Docket Item # 19
BAR CASE # 2008-0199

BAR Meeting
November 5, 2008

ISSUE: Alterations
APPLICANT: Benjamin and Kira Brooks
LOCATION: 523 South Lee Street
ZONE: RM/Residential

Figure 5: Plan showing arbor and fence location

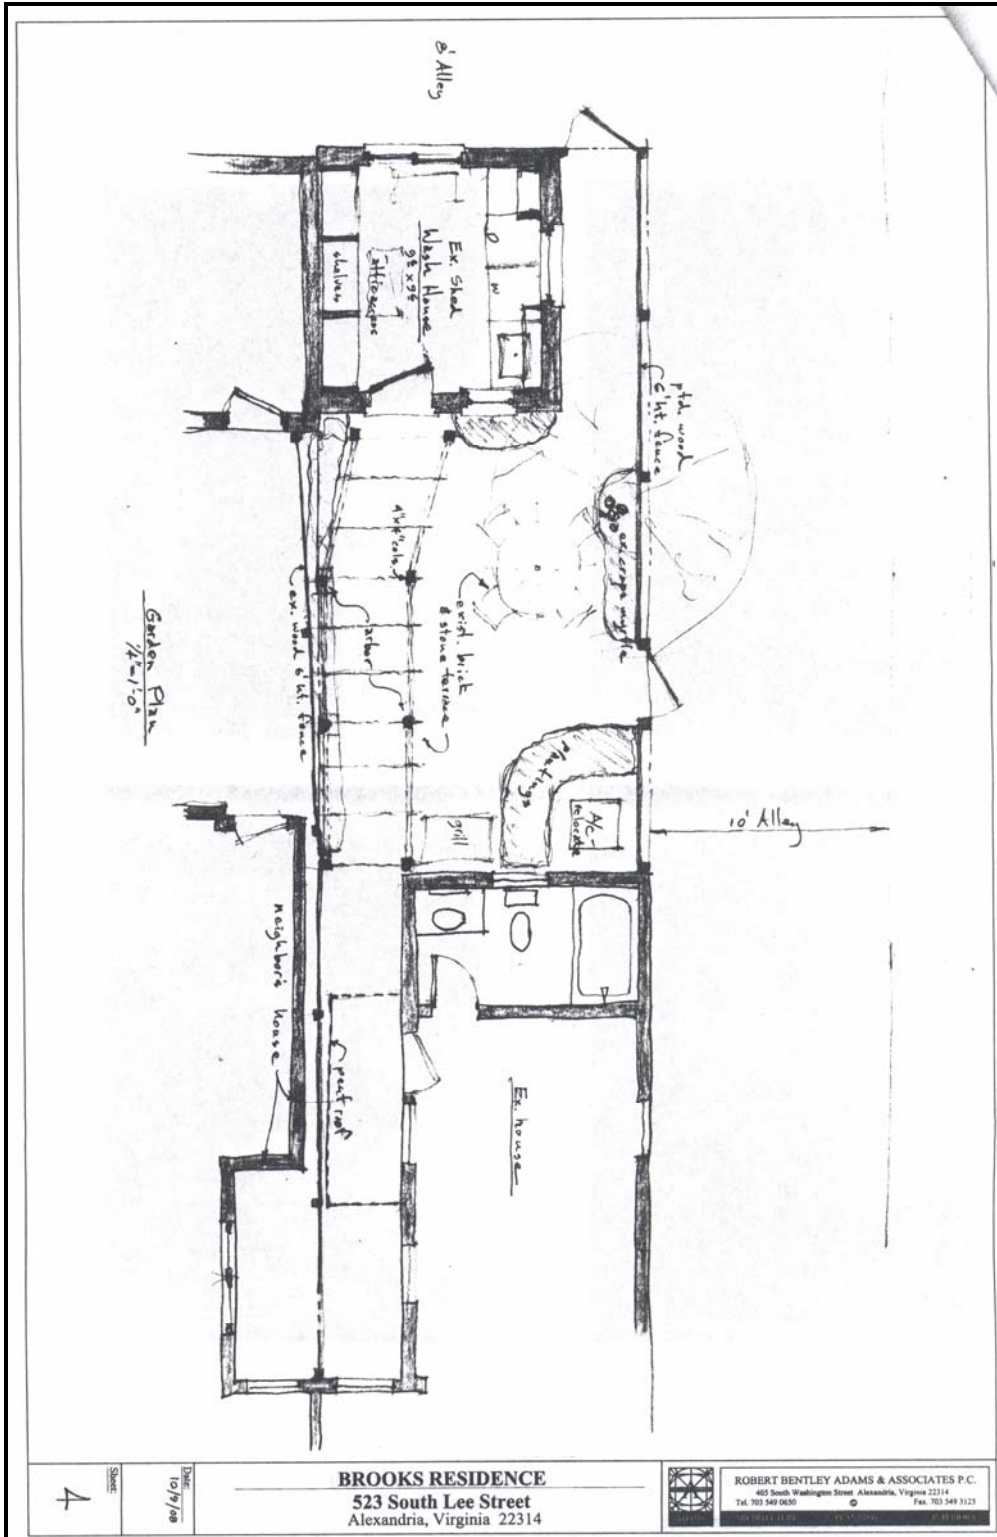
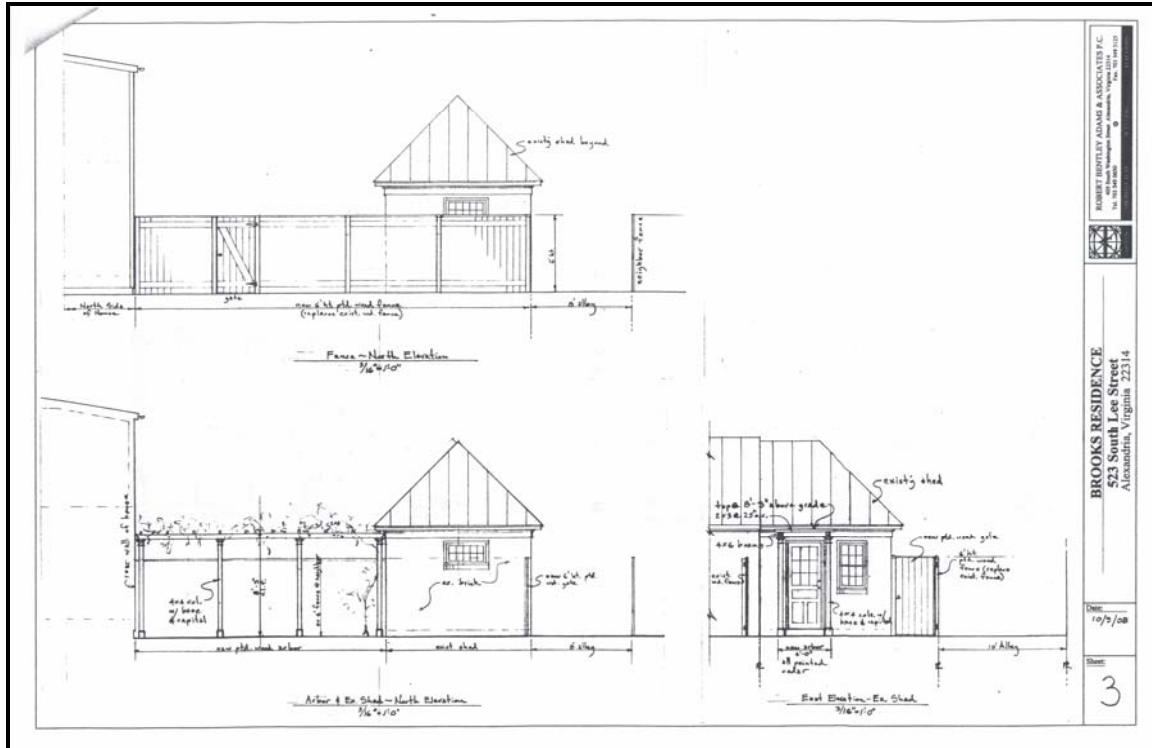
Staff supports the applicant's request for a new arbor and replacement fence. The fence will be an improvement over the existing, ivy covered fence and will be an attractive addition to the rather utilitarian alley next to and behind 523 South Lee Street. In addition, Staff believes that the arbor complements the main building, as recommended in the *Design Guidelines*. Both projects meet the *Guidelines* recommendations pertaining to either painting or staining accessory structures and fencing.

Figure 7: Elevation from September 3, 2008 BAR submission showing rear chimney

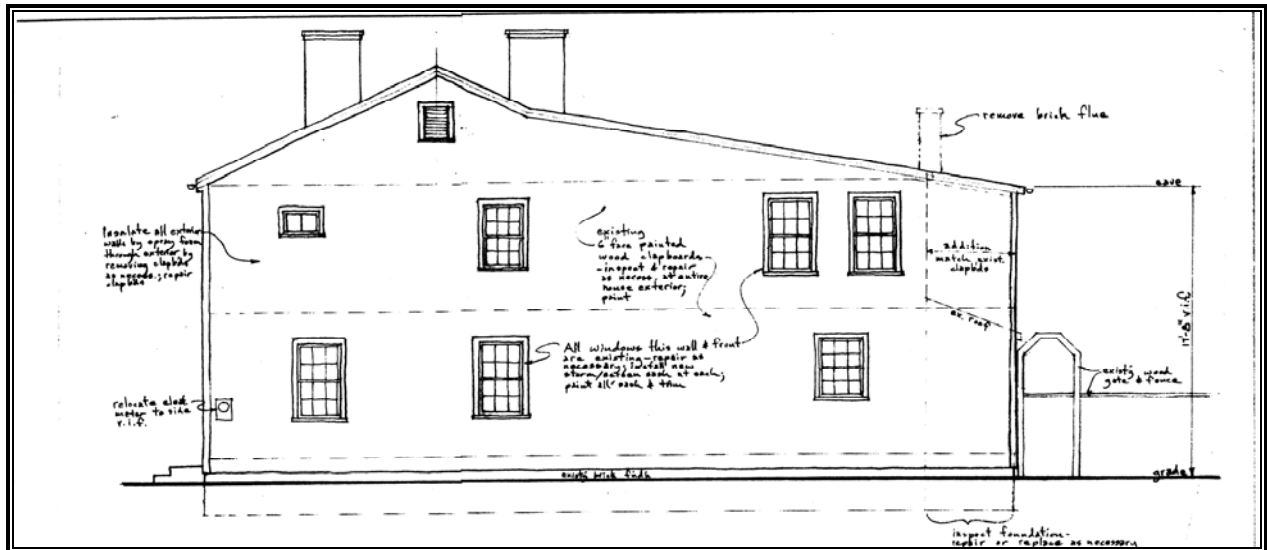
When the proposed addition for 523 South Lee Street was brought before the Board in September of this year, the BAR specifically conditioned their approval on the retention of the rear chimney. After the hearing, the applicant's architect completed detailed construction drawings for the proposed addition and determined that the retention of the brick chimney would

Figure 8: Section showing relocated chimney dated September 24, 2008.

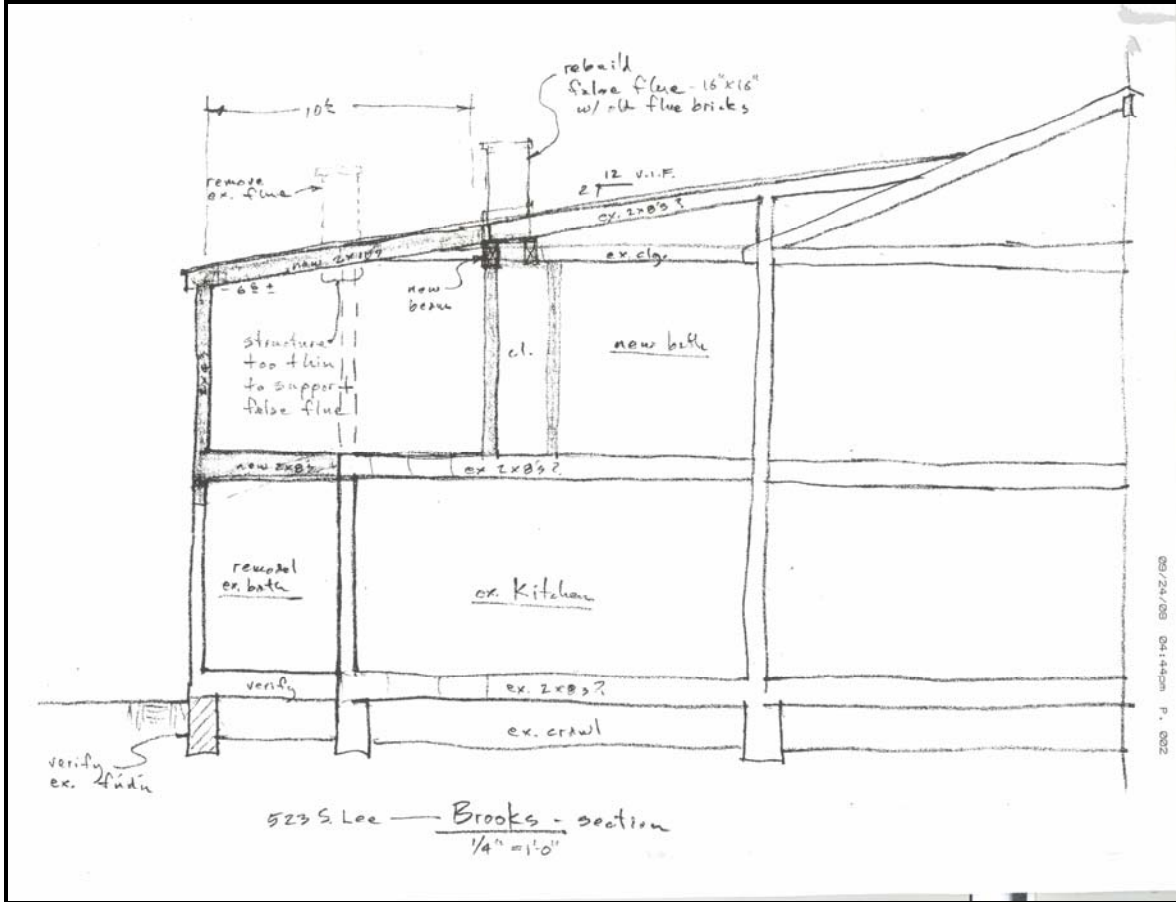
be costly because the flue would need to be removed and the chimney would need to be stabilized. The applicant was particularly concerned about safety issues because the chimney would be over a bedroom and would have to be stabilized to withstand a 90mph windload resistance, which they state would not be sufficient in a hurricane or tornado). When the applicant's architect first approached Staff about the potential removal of the chimney they showed an alternative location to rebuild the chimney approximately 6' to the east (see attached drawing dated September 24, 2008). Although Staff would prefer to see the chimney retained in situ, Staff can support the relocation of the chimney because the visibility of the rear chimney will be limited to the side and rear alley and not South Lee Street and it will be located over an interior closet and not the new second story bedroom addition.

1. That the rear chimney be relocated to the east approximately 6', as shown in the attached sketch dated September 24, 2008;
2. That the following statement appear in the General Notes of all site plans and on all site plan sheets that involve demolition or ground disturbance (including Basement/Foundation Plans, Demolition, Erosion and Sediment Control, Grading, Landscaping, Utilities, and Sheeting and Shoring) so that on-site contractors are aware of the requirements:
